20/0011/FUL | Land near Pinn Lane, Monkerton, Exeter, Devon EX1 3QF

Exeter Cycling Campaign object to the proposed Pinn Lane Cycleway on grounds that it does not adequately or safely meet Condition 21 of the Planning Permission granted for the Sandrock site.

Figure 2: Yellow dashed line indicates proposed safe segregated walking and cycling route as far as existing footpath. For people walking the route needs to connect onto Grenadier road either at the end of Pinn Lane or at the south end of the footpath.

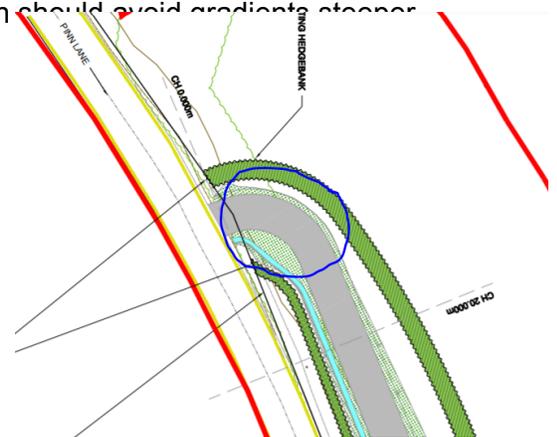
2. The proposed route does not connect safe cycling and walking routes at both ends. The southern end of the proposed new path merely ends in the middle of Pinn Lane. For people on bicycles travelling south, this will require crossing both lanes of vehicular traffic at an area of poor visibility in order to join the existing highway to continue travelling south. For people walking this will require walking along the highway with no footpath until joining the existing footpath on the west of Pinn Lane at the southern end. As a result, this new route does not improve safety for people on bicycles or walking and thus does not meaningfully meet the requirements of Condition 21.

In order to mitigate 2, we propose that the design is modified in line with Figure 1 to extend a continuous path along the full length of Pinn Lane. A safe connection should be made onto the existing footpath for walkers and onto Grenadier Road for bicycle users either via the existing footpath (which will require removal of the barriers at the south end and a priority crossing for bicycles to join onto the road in both directions) or at the junction of Pinn Lane (with a priority crossing for bicycles to join onto the road in both directions). To ensure a continuous safe path may require a narrowing for car users, creating a narrowed one lane section with give way markings. This will have the added benefit of slowing cars along this section.
